DRWG No DA-02-C
PROPOSED SITE PLAN

DA2023/0493

PROPOSED ALTERATIONS TO FRONT FENCE AND ENTRY AND UNIT 4 BALCONY AND ASSOCIATED WORKS AT 8 OCEAN ROAD MANLY 2095 SP 14402			FOR THE OWNERS SP 14402		KUBANYI ARCHITECTS NSW REG 4087 DEP 0000592 LEVEL 1, 122 VICTORIA ROAD DRUMMOYNE 2047 PH 0412 500 240 JUDITHKUBANYI@IINET.NET.AU				DRWG NoDA-A03- D PLAN AT GFL LEVEL
					Scale 1:100@A3	Date April 14 2023	Drawn jk		
								issue DA

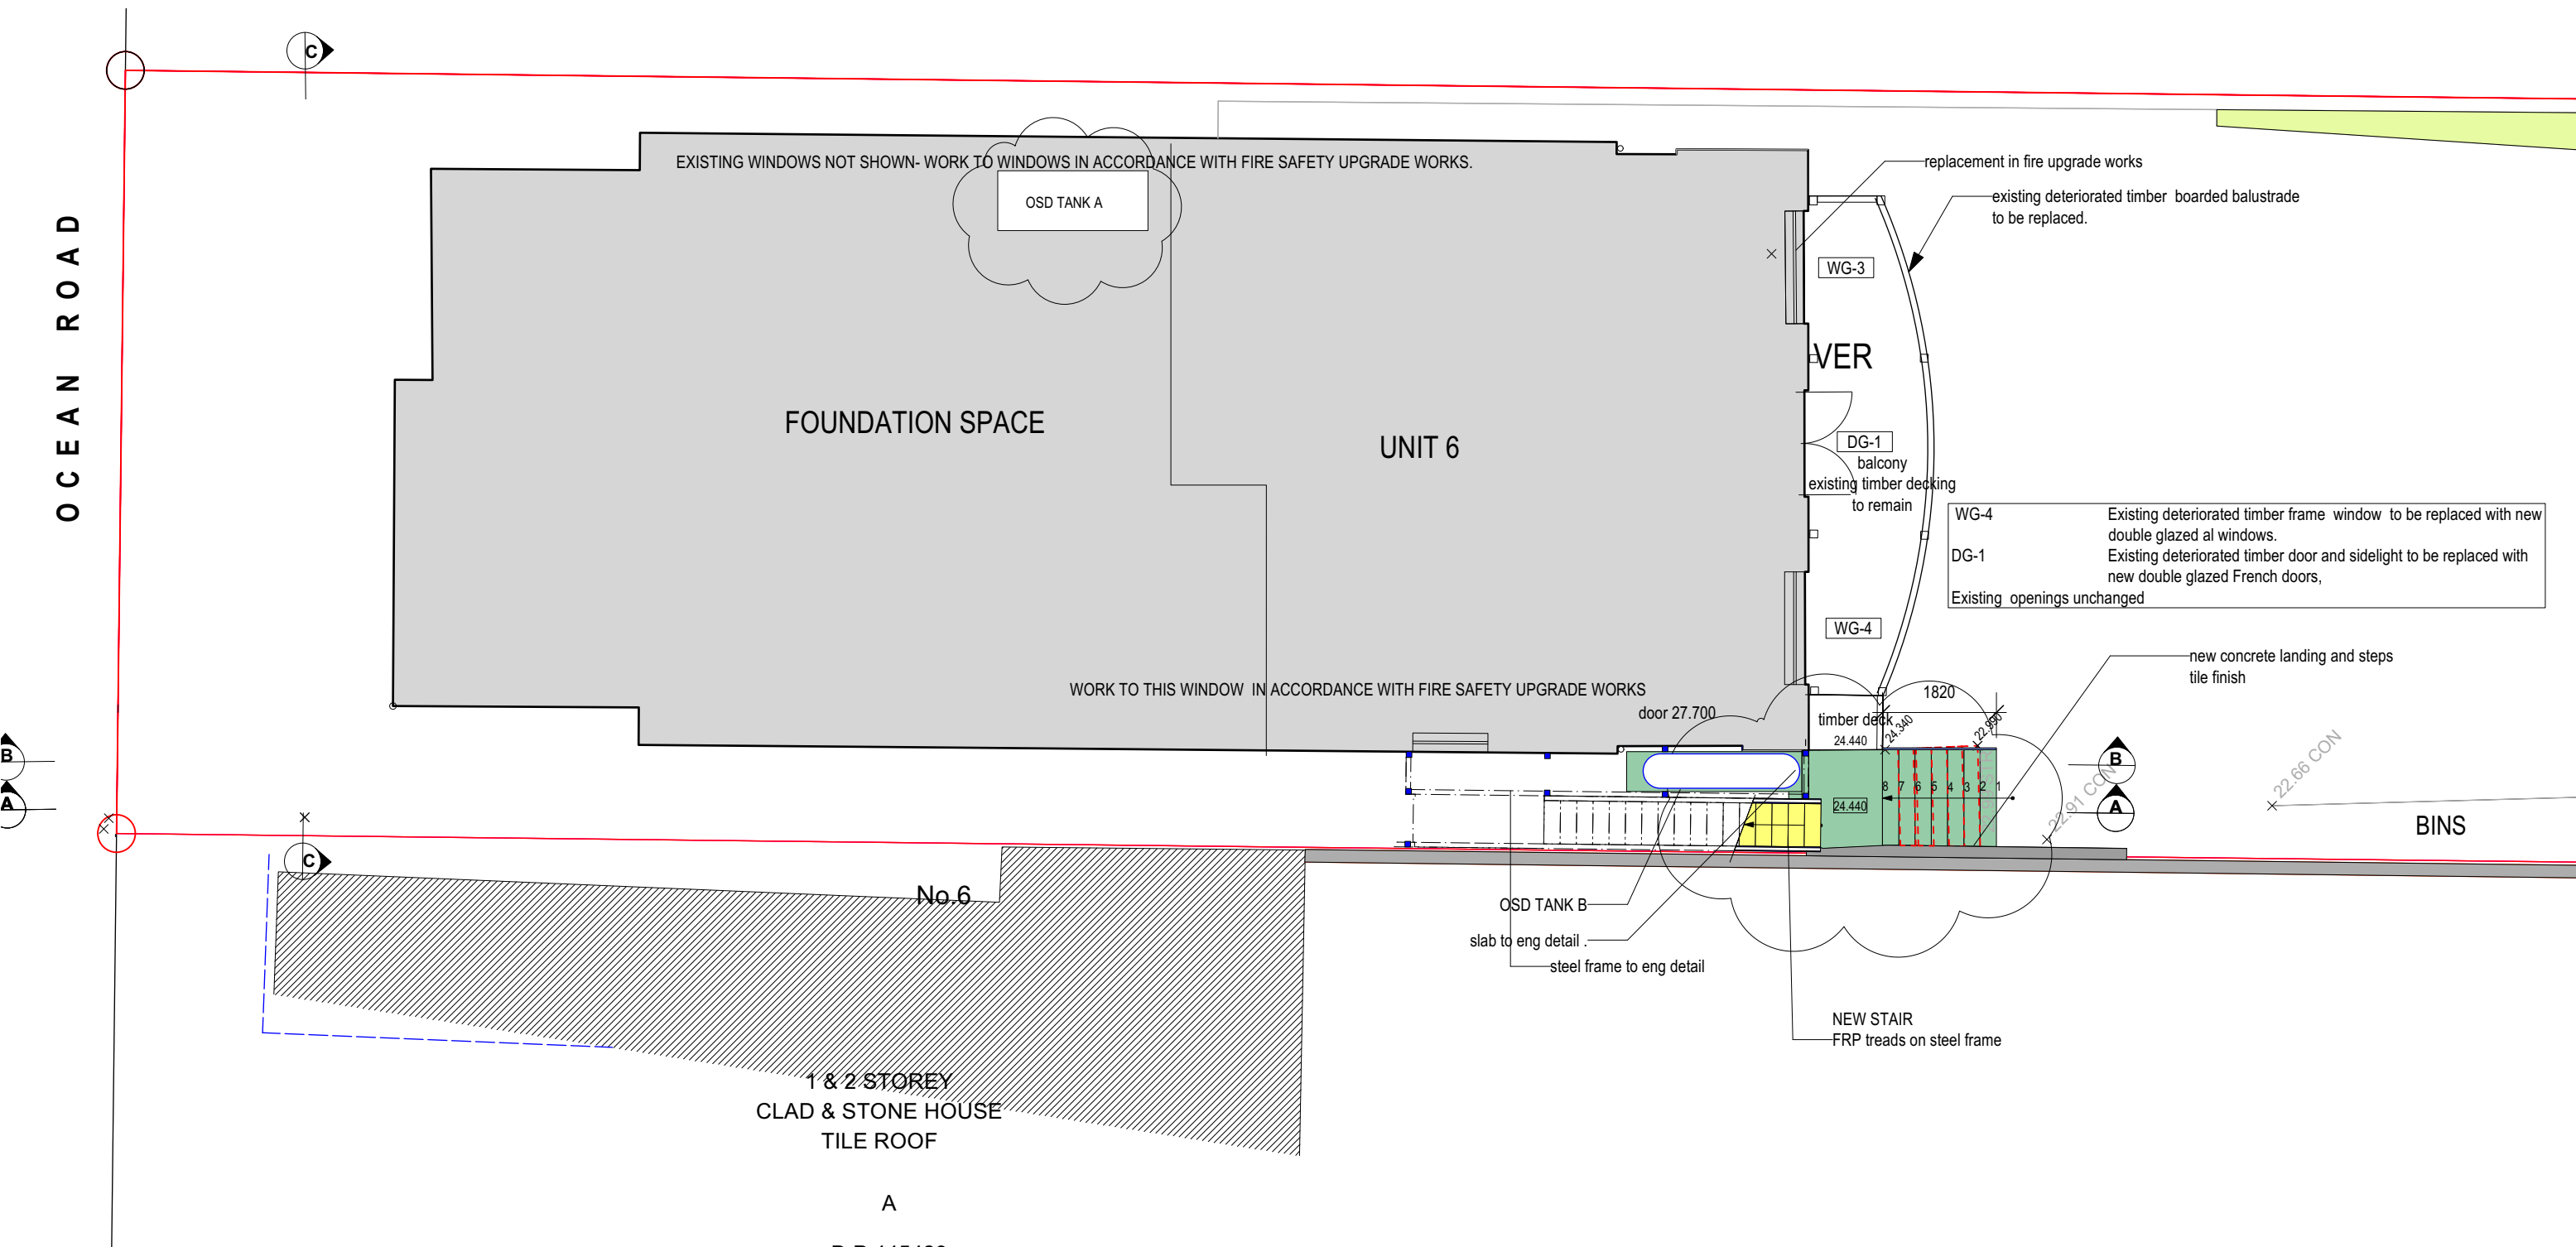
C	12.9.2023	slab and supporting structure required for sprinkler booster valve assembly deleted from this application as it is required Fire Safety Upgrade works . Replacement of partially collapsed retaining wall on NW corner of site added.
B	25.7.2023	reference to currently approved DA 2020/0875 deleted. new landing and stairs shown this DA

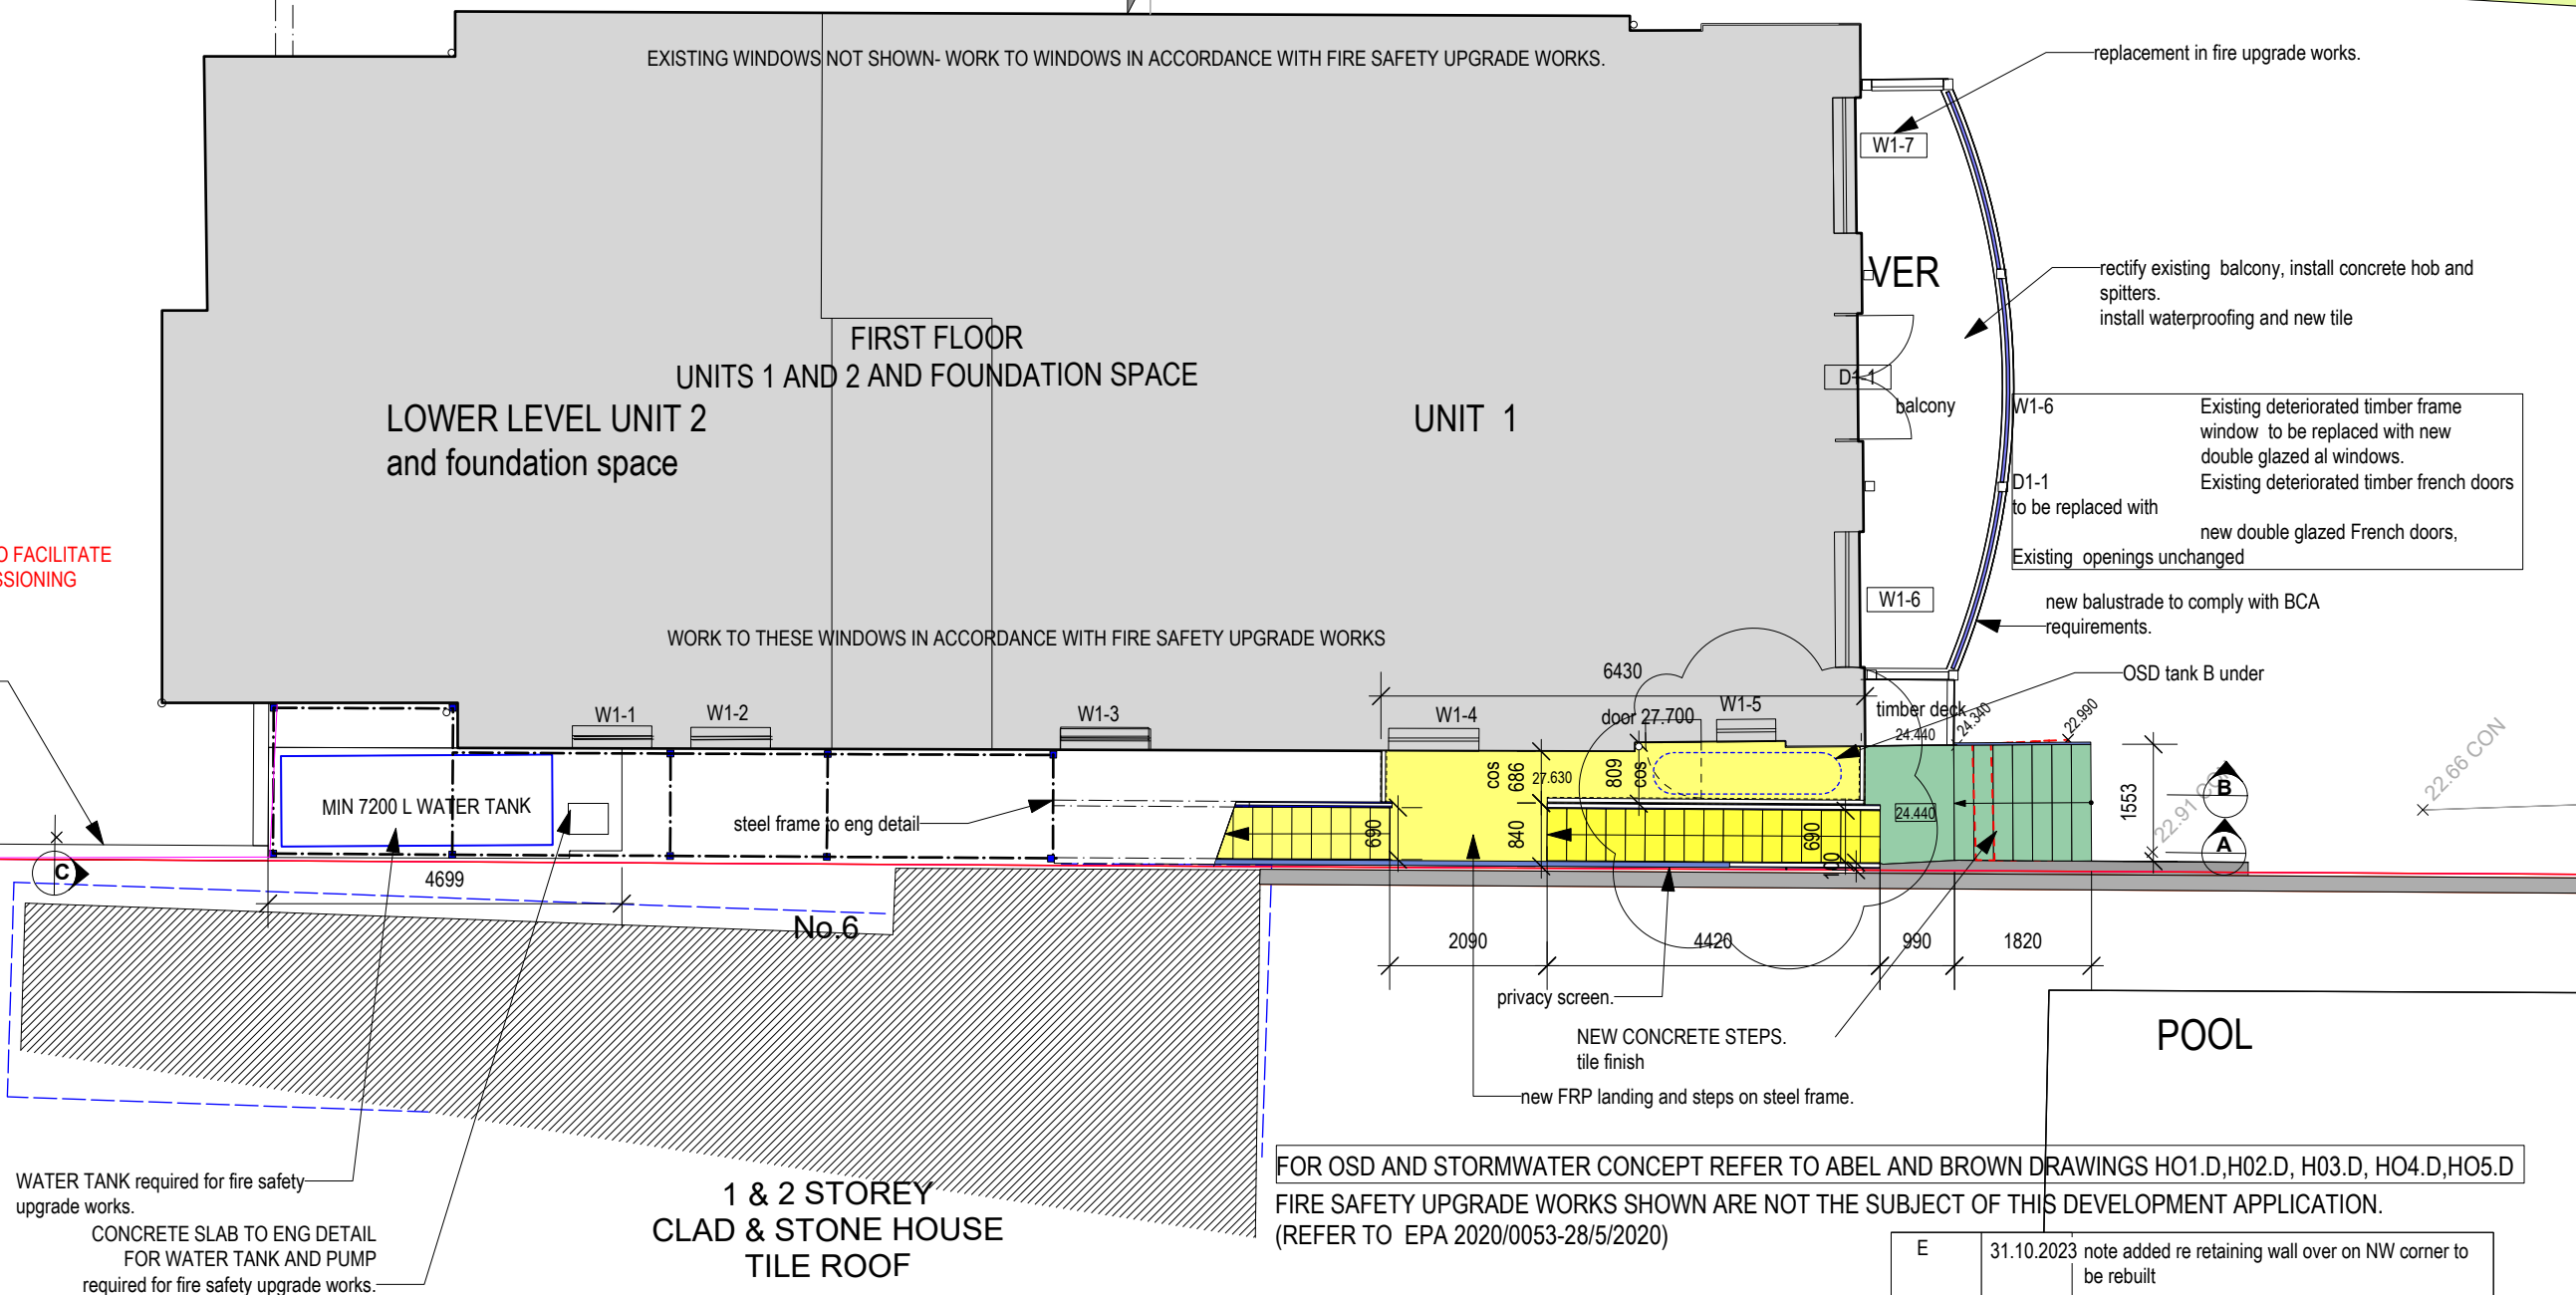
D	12.9.2023	OSD tank locations amended
C	7.8.2023	OSD tank locations shown
B	25.7.2023	reference to currently approved DA 2020/0875 deleted. new landing and stairs shown this DA

DRWG No DA-A04-E
PLAN AT 1ST FLOOR
LEVEL

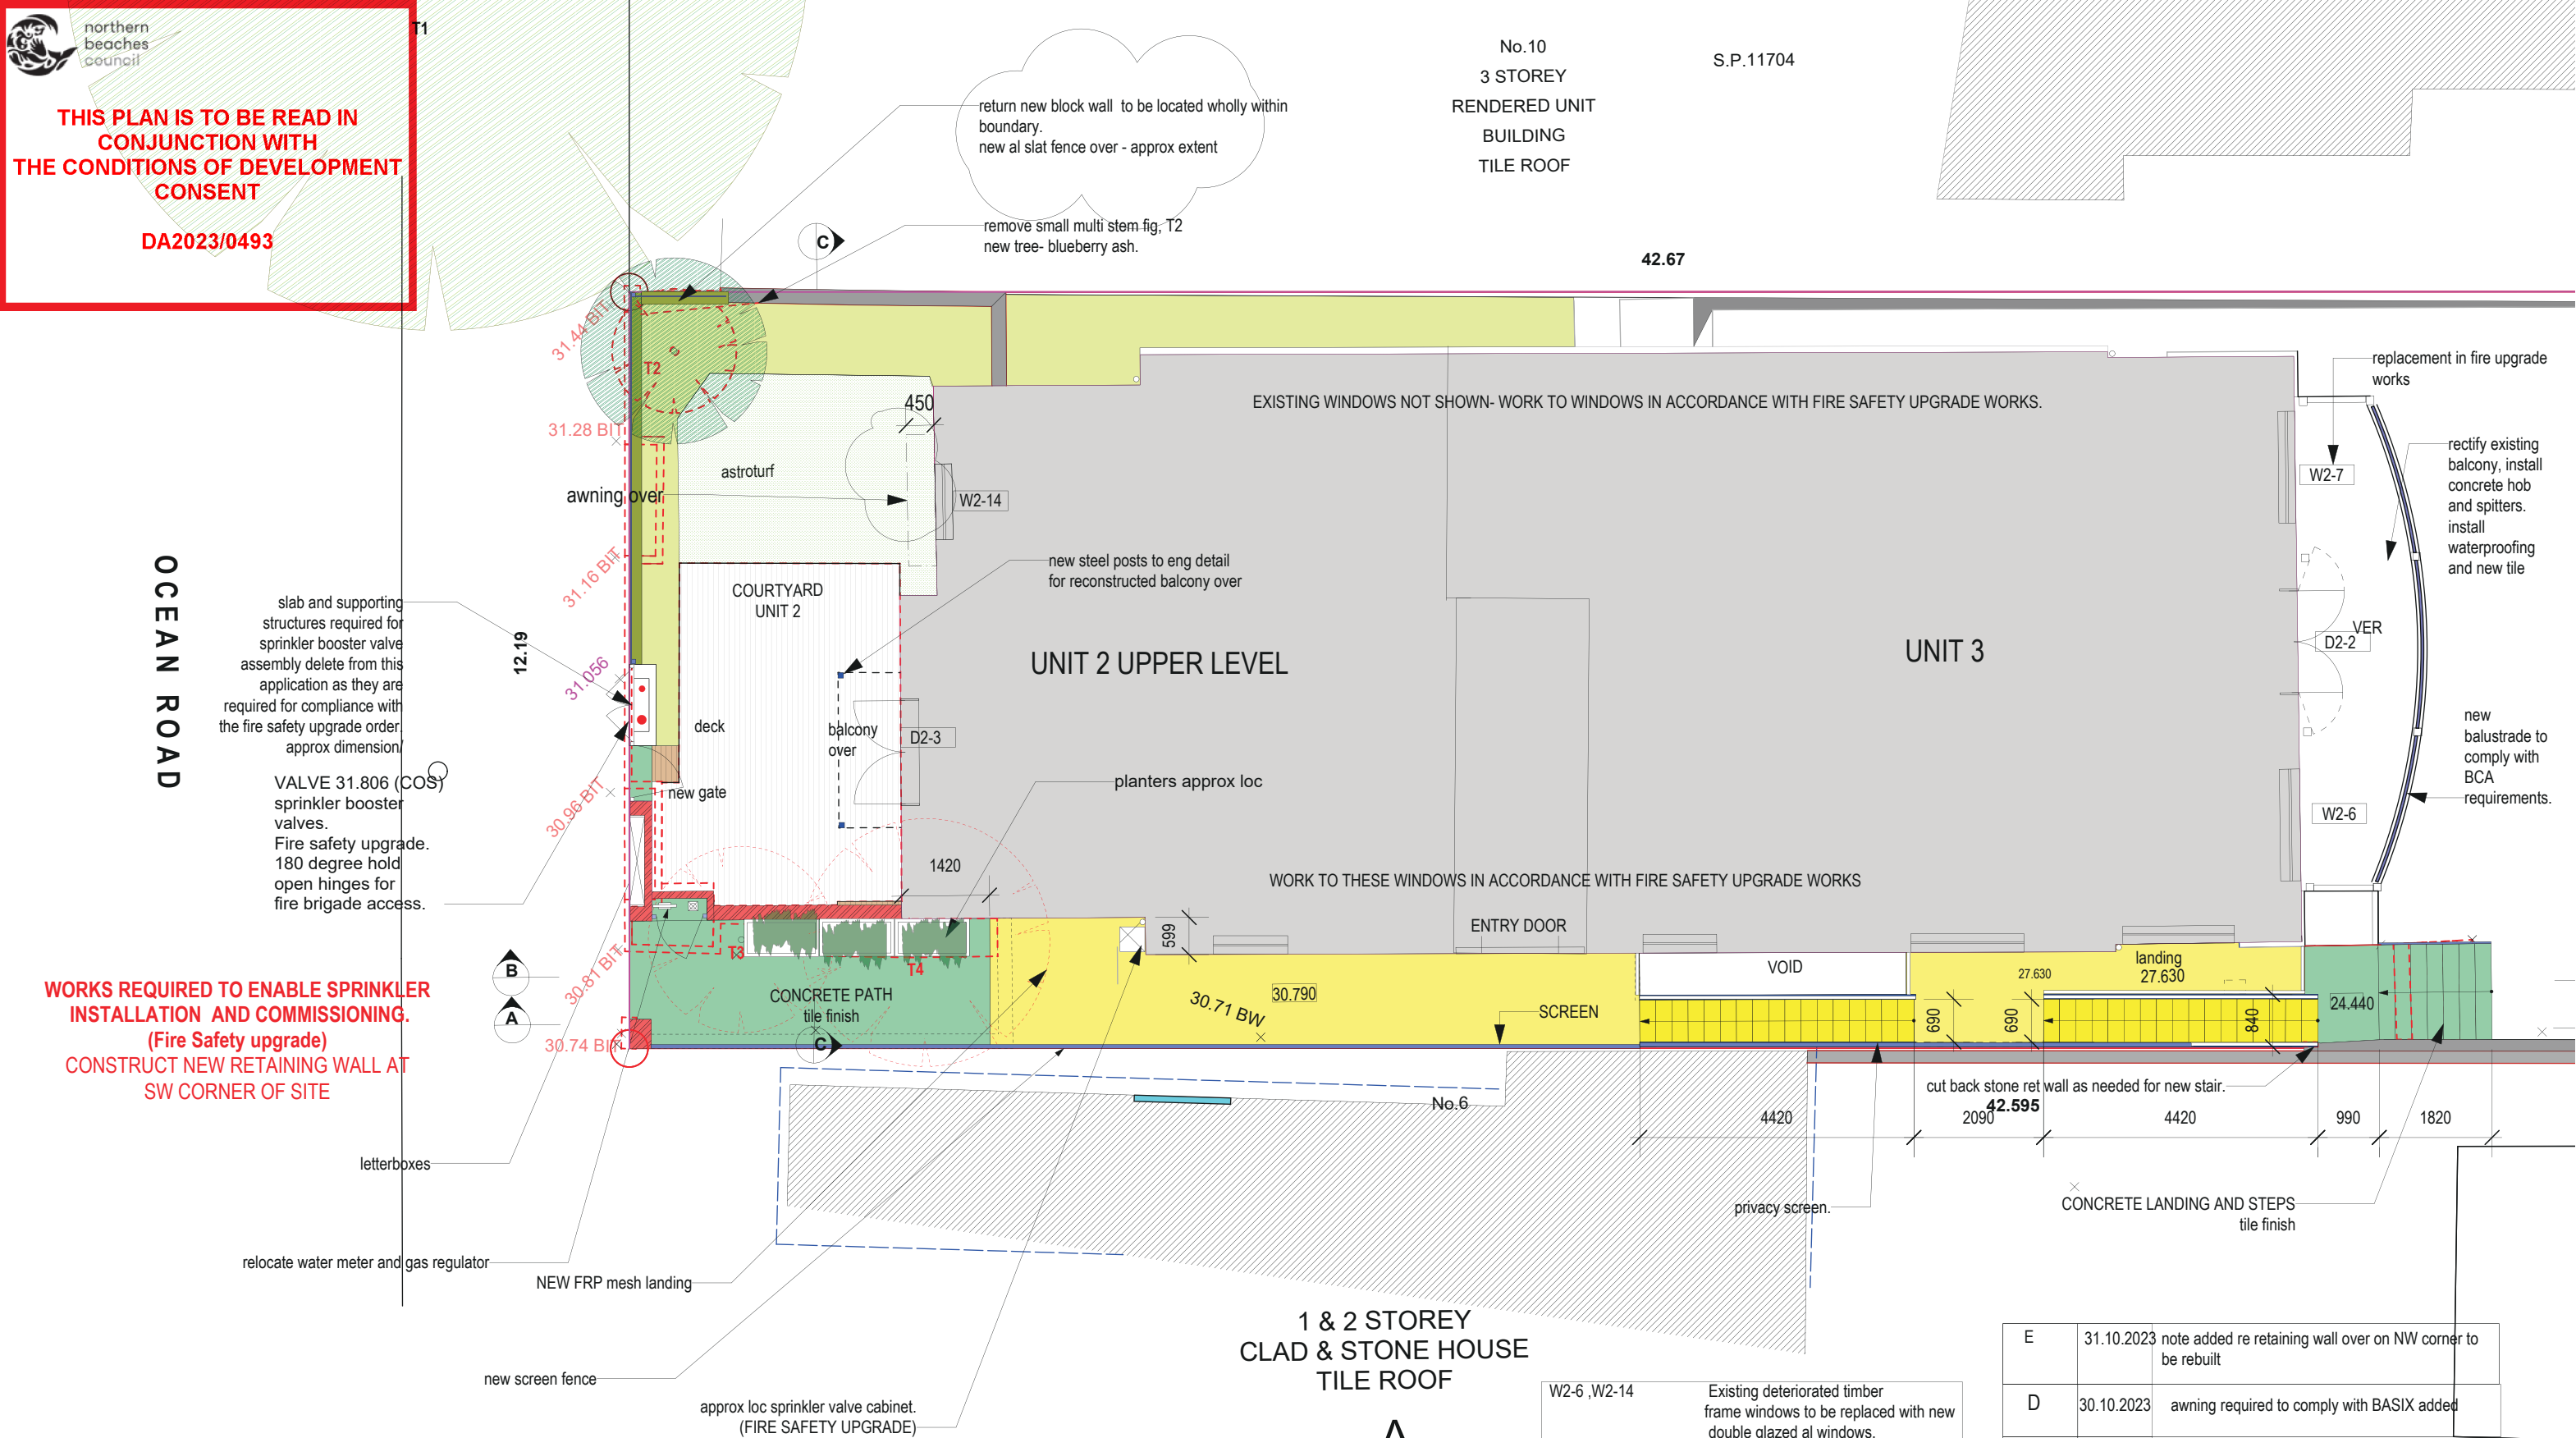
E	31.10.2023	note added re retaining wall over on NW corner to be rebuilt
D	12.9.2023	retaining wall deleted from DA- required to enable fire safety upgrade works. amendment to OSD
C	7.8.2023	OSD tank location shown
B	25.7.2023	reference to currently approved DA 2020/0875 deleted. new landing and stairs shown this DA
